**National Fire Protection Association**

**WORKING DRAFT OF NEC CODE-MAKING**  
**PANEL 13 MEETING OUTPUT**

**Document: National Electrical Code®**

**Revision Cycle: A2025**

Figure Informational Note Figure 700.10(B)(1) Single or Multiple Feeders Without Overcurrent Protection.

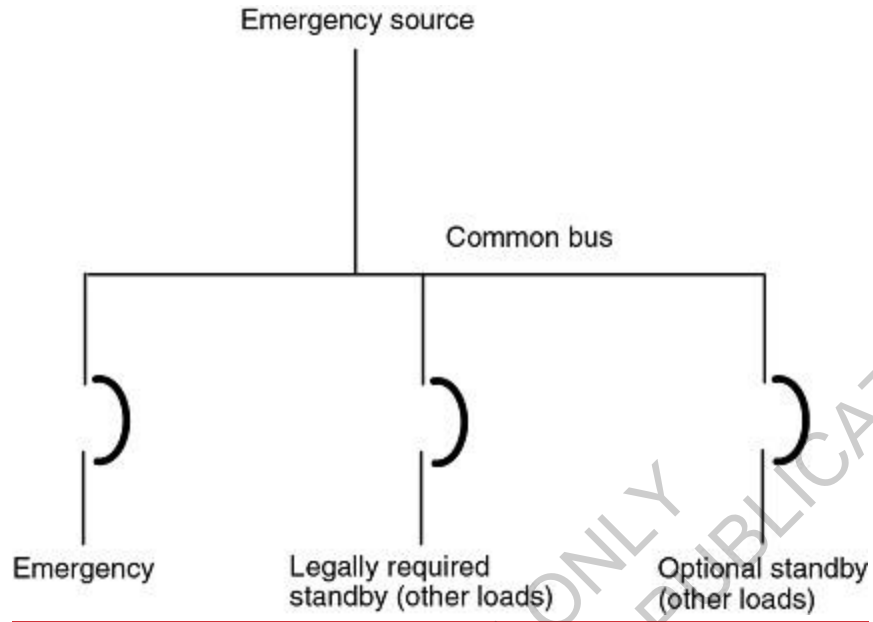
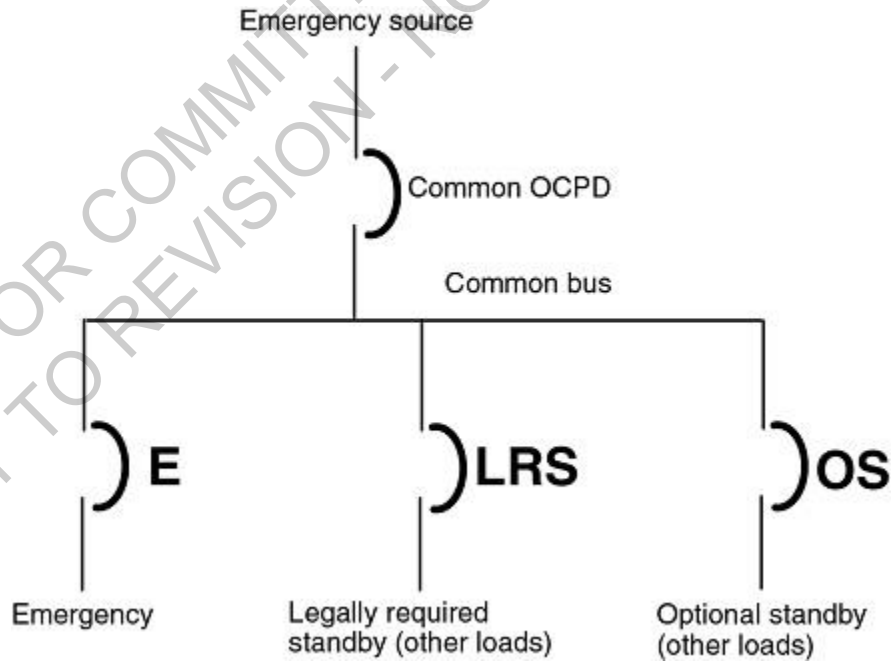
Informational Note: See Informational Note Figure 700.10(B)(1) and Informational Note Figure 700.10(B)(2) for further information.

- Emergency circuits shall not originate from the same vertical switchgear section, vertical switchboard section, panelboard enclosure, or individual disconnect enclosure as other circuits.

4. It shall be permissible to use single or multiple feeders to supply distribution equipment between an emergency source and the point where the emergency loads are separated from all other loads.
5. At the emergency power source, such as a generator, multiple integral overcurrent protective devices shall each be permitted to supply a designated emergency or a designated nonemergency load, provided that there is complete separation between emergency and nonemergency loads beginning immediately after the overcurrent protective device line-side connections.

There is now a defined term for automatic load control relay (ALCR) and adding it to this section improves useability. There is also use of emergency lighting control device (ECLD) and that is a defined term and a device covered by section 700.10(B)(3). The term interconnection equipment was added to correlate with the permitted emergency sources in 700.12.

**Figure Informational Note Figure 700.32(C) Emergency System Selective Coordination.**

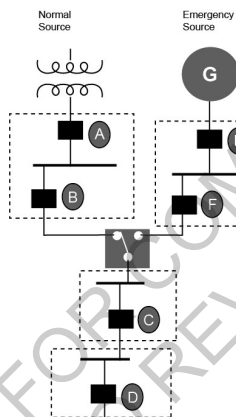
Informational Note: See Informational Note Figure 700.32(C) - for an example of how emergency system OCPDs selectively coordinate with all supply-side OCPDs.

OCPD F selectively coordinates with OCPD E.

OCPD B is not required to selectively coordinate with OCPD A because OCPD B is not an emergency system OCPD.

**Committee Statement:** The change provides clarity on maintaining selective coordination with the normal system and provides correlation with section 240.11.

Also, the revision reaffirms the language in TIA. 23-11. This change removes the reference to Part C in the Informational Note and Figure in 700.32

**Figure Informational Note Figure 701.32(C) Legally Required Standby System Selective Coordination.**

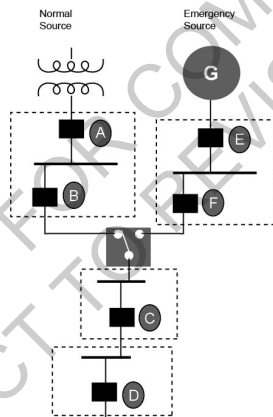
Informational Note 2: See Informational Note Figure 701.32(C) for an example of how legally required standby system OCPDs selectively coordinate with all supply-side OCPDs.

OCPD F selectively coordinates with OCPD E.

OCPD B is not required to selectively coordinate with OCPD A because OCPD B is not a legally required standby system OCPD.

The change to the body of (C) provides clarity on maintaining selective coordination with the normal system and provides correlation with section 240.11.

Also, the revision reaffirms the language in TIA. 23-11. This change removes the reference to Part C in the Informational Note and Figure in 701.32

**Figure Informational Note Figure 708.54(C) Critical Operations Power System Selective Coordination.**

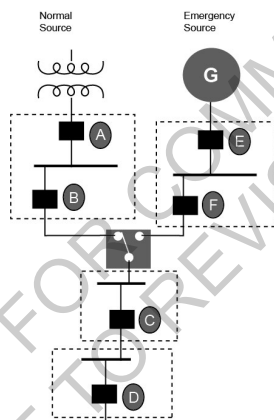
Informational Note: See Informational Note Figure 708.54(C) - for an example of how critical operations power system OCPDs selectively coordinate with all supply-side OCPDs.

OCPD F selectively coordinates with OCPD E.

OCPD B is not required to selectively coordinate with OCPD A because OCPD B is not a critical operations power system OCPD.

**Committee Statement:** The change was made to help enhance the safety and reliability of a critical operations power system by adding clarity to what overcurrent protective devices shall be reevaluated when replacements are made.

Also, the revision reaffirms the language in TIA. 23-11. This change removes the reference to Part C in the Informational Note and Figure in 708.54
